**CITY OF TEMPE
DEVELOPMENT REVIEW COMMISSION**

Meeting Date: 02/28/2017
Agenda Item: 4

ACTION: Request for an Amended Planned Area Development Overlay and a Development Plan Review for Phase 1B consisting of a new seven-story, multi-family residential building for AURA WATERMARK (PL160311), located at 430 North Scottsdale Road. The applicant is Withey Morris PLC.

FIRE ACCESS PLAN

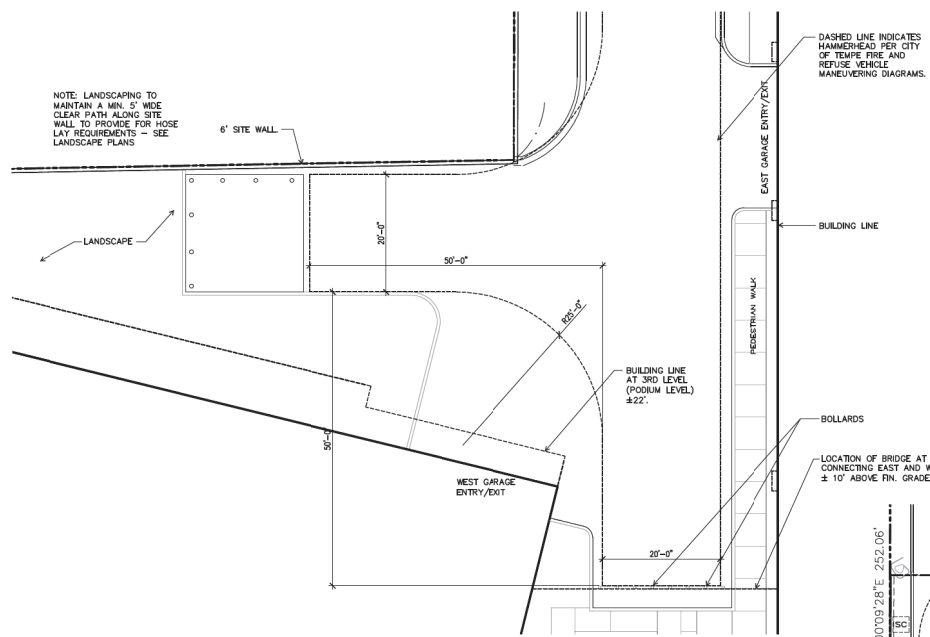
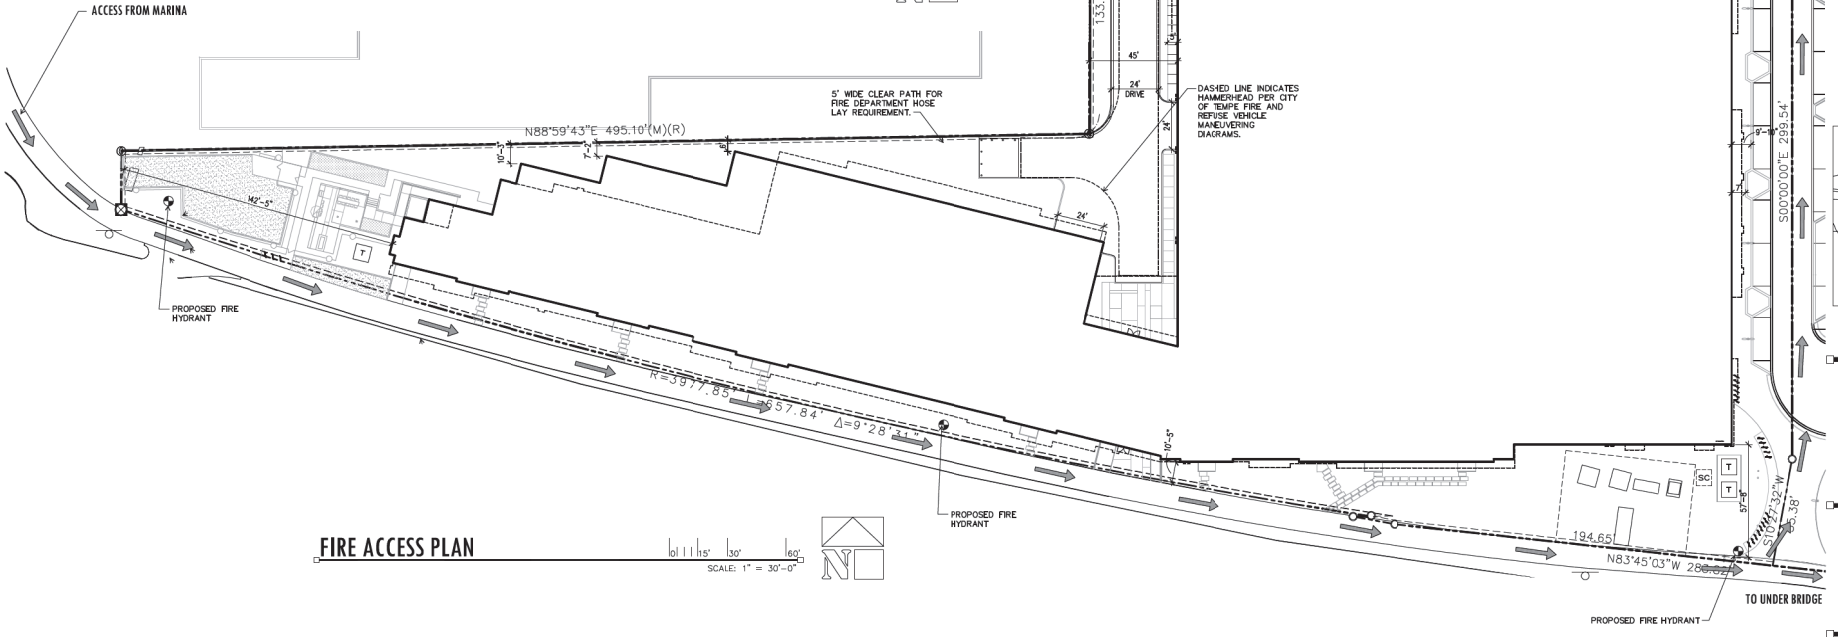
- Clearly define the fire lanes. Ensure that there is at least a 20'-0" horizontal width, and a 14'-0" vertical clearance from the fire lane surface to the underside of tree canopies or overhead structures. Layout and details of fire lanes are subject to Fire Department approval.
- Provide a fire command room(s) on the ground floor of the building(s). Verify size and location with Fire Department.

A4.10
PRELIMINARY ELEVATIONS

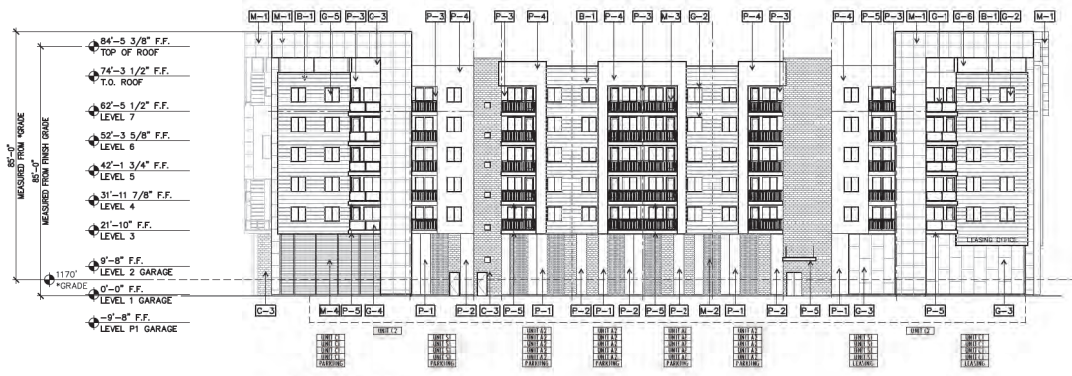
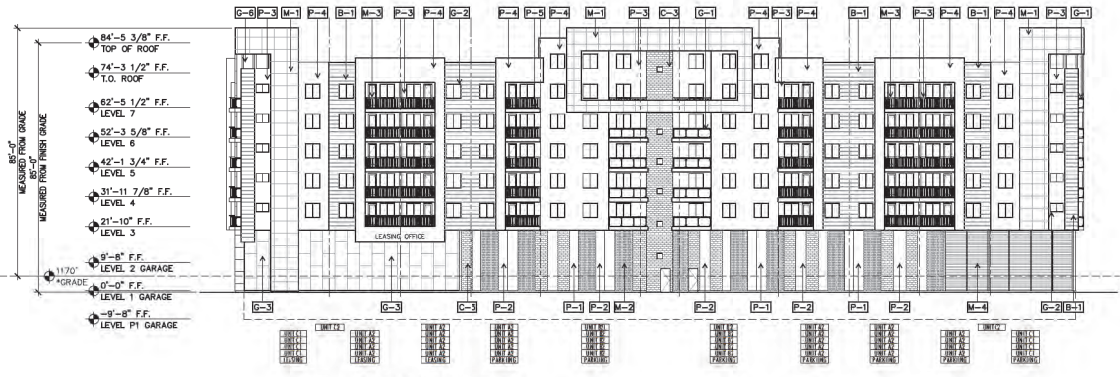
15. Provide decorative canopies along north and east sidewalks adjacent to building to improve pedestrian environment. Compliance with this modification shall be confirmed by the Planning Division prior to issuance of permits.

16. Replace smooth CMU with ground face CMU at podium level and locations where smooth CMU begins extends beyond podium level. Ground face CMU applied should be complimentary to proposed color palette for building. The following elevations are excluded from having to meet this requirement; northeast, west and all building façades located in interior amenity courtyards. Compliance with this modification shall be confirmed by the Planning Division prior to issuance of permits.

CLS-1
 GROUND LANDSCAPE PLAN

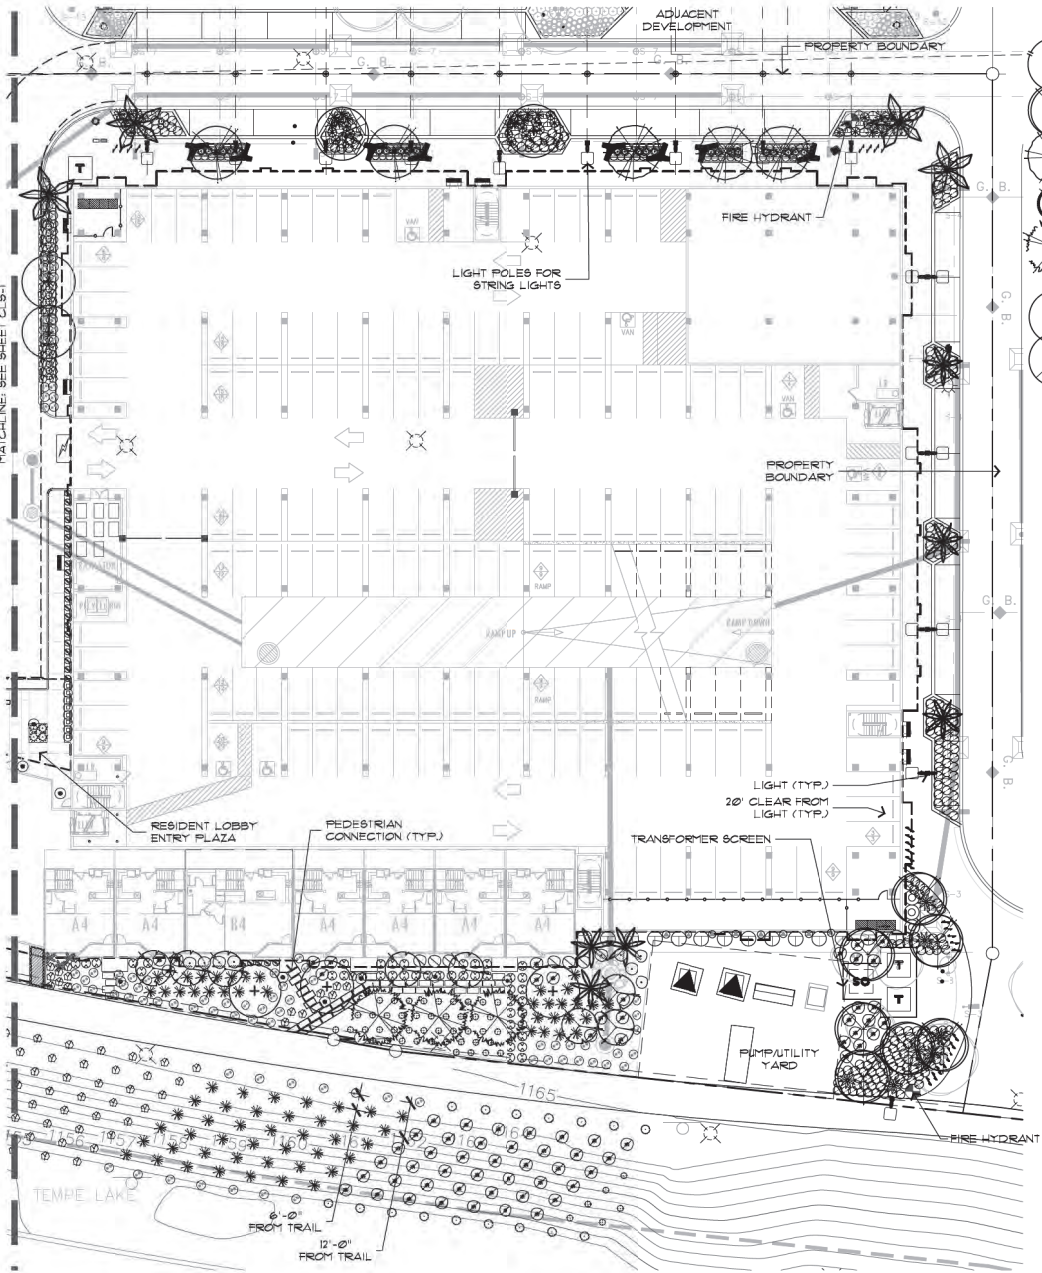
24. Nerium Oleander specimens shall not be located within twelve (12) feet of sidewalks or pedestrian pathways. In areas where this circumstance exists on landscape plan shall be replaced with a different specimen. Refer to Section 4-702G and Appendices B & C of the Zoning and Development Code.
25. Arterial street trees shall be a minimum of 36" box specimens and a minimum of 1 ½" caliper trunk.
26. Irrigation notes:
 - a. Provide dedicated landscape water meter.
 - b. Provide pipe distribution system of buried rigid (polyvinylchloride), not flexible (polyethylene). Use of schedule 40 PVC mainline and class 315 PVC ½" feeder line is acceptable. Class 200 PVC feeder line may be used for sizes

- e. Controller valve wire conduit may be exposed if the controller remains in the mechanical yard.
27. Include requirement to de-compact soil in planting areas on site and in public right of way and remove construction debris from planting areas prior to landscape installation.

28. Top dress planting areas with a rock or decomposed granite application. Provide rock or decomposed granite of 2" uniform thickness. Provide pre-emergence weed control application and do not underlay rock or decomposed granite application with plastic.

29. Trees shall be planted a minimum of 20'-0" from any existing or proposed public water or sewer lines. The tree planting separation requirements may be reduced from the waterline upon the installation of a linear root barrier, a minimum of 6'-0" parallel from the waterline, or around the tree. The root barrier shall be a continuous material, a minimum of 0.08" thick, installed 0'-2" above finish grade to a depth of 8'-0" below grade. Final approval subject to determination by the Public Works, Water Utilities Division.

TRANSFORMERS SCREEN FENCE

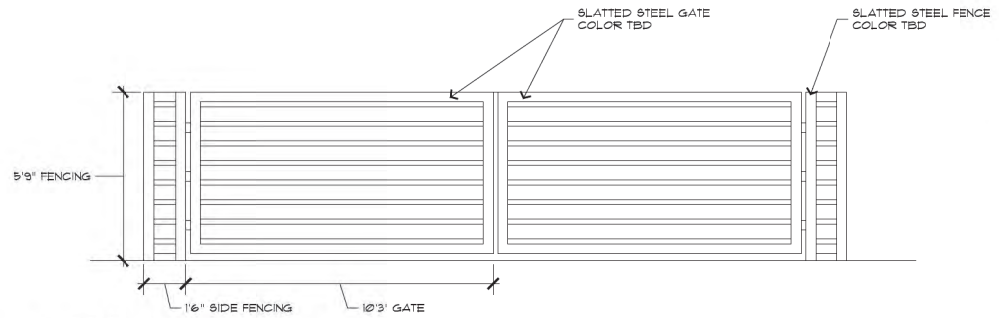
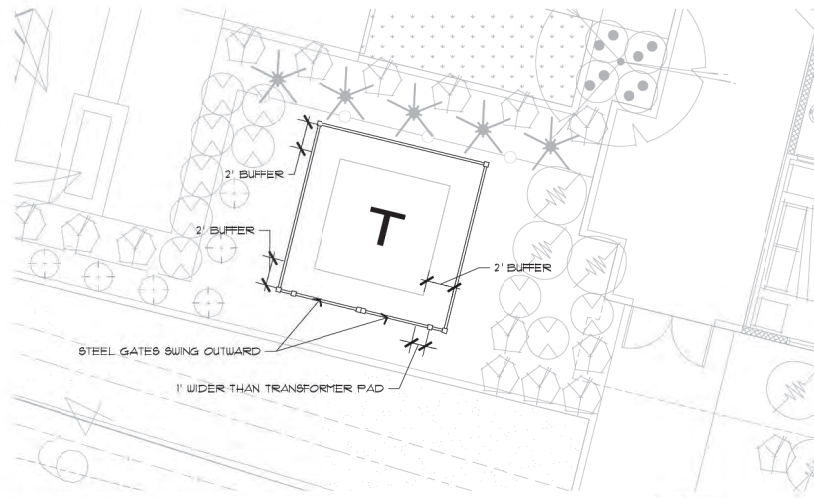
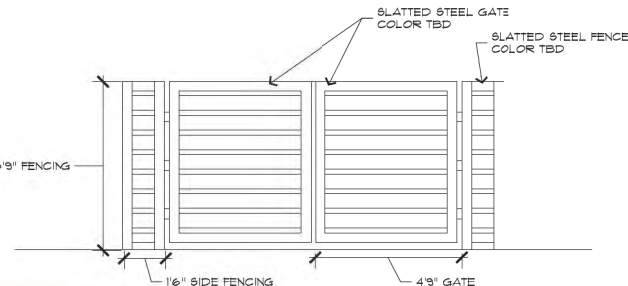
6. Screening for transformers and utility equipment boxes should be decorative and match building design. Compliance with this modification shall be confirmed by the Planning Division prior to issuance of permits.
